Dolwende Quarry Project

Supplementary Response to Submissions Report

Upper Hunter Holdings Pty Ltd

17 October 2016

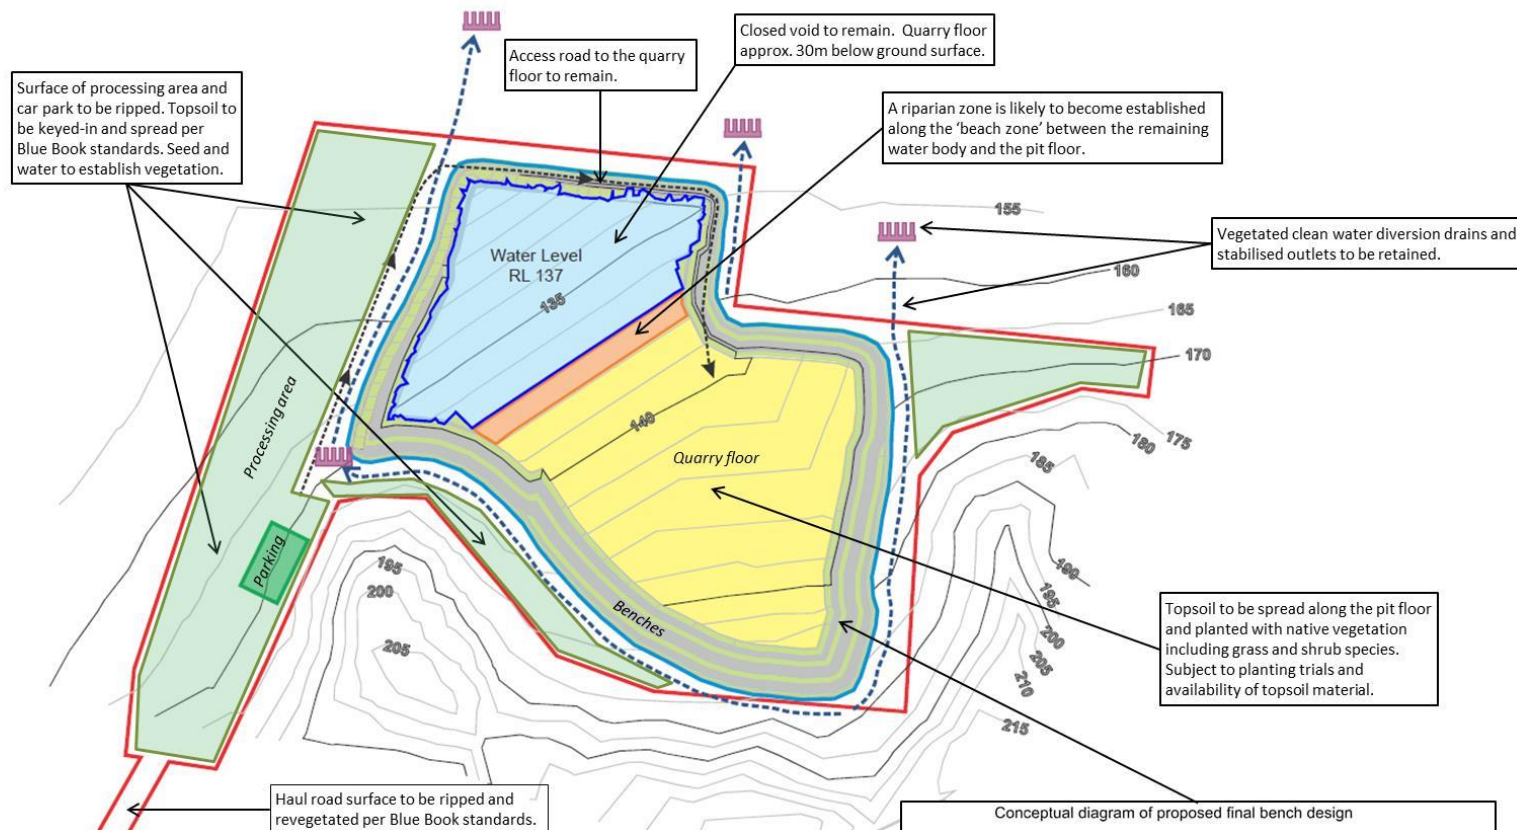
26.	<p><u>Email from RMS to DPE, 9/8/2016:</u></p> <p>Roads and Maritime do not have any recent traffic data at this location. There is a permanent count station (05.223) on the northern end of Denman as you leave town, reviewing the growth</p>	<p>Noted. This information supports UHH's position that no further traffic surveys are required.</p>

<p>trend at this count station it appears that there has not been significant growth with approximately 1.5 % growth between 2012 and 2015.</p> <p>Please refer to Roads and Maritime's Traffic Volume Viewer http://www.rms.nsw.gov.au/about/corporate-publications/statistics/traffic-volumes/aadt-map/index.html#/?z=6</p> <p>Roads and Maritime's response in regards to the upgrade of the intersection at the site was based on the safety issue of trucks entering and exiting the site. Requesting an updated traffic survey would not change Roads and Maritime's response to this proposal.</p>	
DPI Water

Conceptual Rehabilitation Plan Drawing

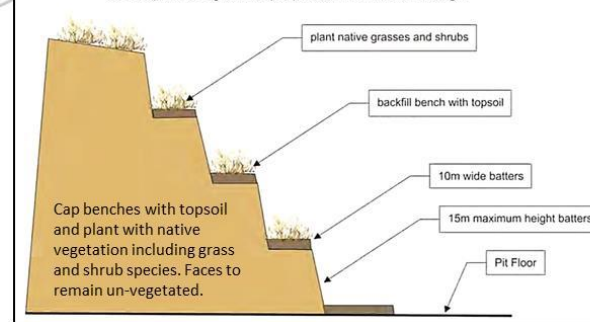
<ul style="list-style-type: none"> In addition, we require a conceptual plan of the final landform of the quarry and how it will be rehabilitated following closure. This is a standard requirement for many SSD quarries, which forms part of a development consent. We also consider this to be particularly necessary due to the use of the uncertain language used to describe the final landform as including a “closed void”. We do not consider this provides the Department, stakeholders, or the community with a clear understanding of whether an acceptable landform would be left in the landscape after extraction is complete. <p>(KMH, July 2016) and clear up any uncertainty, we can confirm that the final landform includes a closed void with a gently sloping quarry floor and benched quarry faces. A closed void is a pit that is not free draining from a drainage perspective, ie it does not have an outlet for stormwater to drain away to the surrounding landscape. This is because the pit would be excavated to approximately 30 m below the surrounding ground level.</p> <p>The key objective of the progressive and final (closure) rehabilitation strategy would be to establish a stable landform that minimises risks to safety and the environment. The rehabilitation objectives and methods would be detailed in a Rehabilitation and Closure Strategy to be prepared at a later stage as the quarry is nearer to closure, approximately during stage 3 of development.</p> <p>The quarry floor and benches would be rehabilitated progressively by suitable means to suppress dust, minimise erosion and minimise potential for weed establishment. The methods employed would be dependent on various factors, not least of which will be the availability of overburden and topsoil for preparation of a suitable growth substrate for revegetation. Native vegetation would be employed where appropriate and subject to the success of planting trials. An access ramp would be maintained to the quarry floor.</p> <p>The proposed final quarry batter faces would remain at a slope of approximately 0.5 horizontal : 1 vertical. The height of these final faces would require review as the quarry develops, in conjunction with the Mines Safety Inspectorate. It is unlikely that the faces will have any vegetation on them as they will not be visible to neighbours, do not pose a significant erosion hazard and the roots of plants can over time destabilise the stratum and make the faces unsafe.</p> <p>Progressive rehabilitation of disturbed areas would be undertaken outside the active extraction area in locations that are disturbed temporarily during construction but not required for operations. This would include, for example, any temporary storage/laydown areas, large or steep road batters, earth bunds and drains conveying concentrated stormwater flows.</p>

<p>As part of a closure plan, the processing and administration areas external to the quarry would be revegetation and returned to a stable condition upon the removal of all equipment and materials. Techniques for rehabilitation would typically include:</p> <ul style="list-style-type: none"> • Ripping surfaces of the processing area and any disturbed lands to be rehabilitated to a depth of 250 mm to key in topsoil; • Spreading topsoil stripped from the site prior to the quarry operations to form a minimum 100mm deep layer; • Seeding with the preferred plant mix; • Watering, fertilising and maintaining vegetation as necessary to ensure successful establishment; and • Maintaining sediment and erosion controls until the site is stable. <p>Clean water diversion drains would be maintained around the high side of the quarry to help maintain the stability of the faces and minimise water capture within the closed void. Safety bunds or fencing would be retained around the perimeter of the extraction area to protect the safety of the public, stock and native fauna.</p> <p>Once extraction and product haulage has ceased the haul road would be rehabilitated, potentially (should the landowner agree) leaving a single lane farm track for access. Rehabilitation of the haul road would include ripping the road surface, spreading topsoil and revegetating.</p> <p>Should it be considered necessary or beneficial to attainment of the rehabilitation objectives, the operators may seek to import clean fill material (ie VENM/ENM) to assist in rehabilitation. For example, to provide supplementary growth materials (topsoil and subsoil) for rehabilitation of the quarry floor if there is a shortage of materials available onsite.</p>
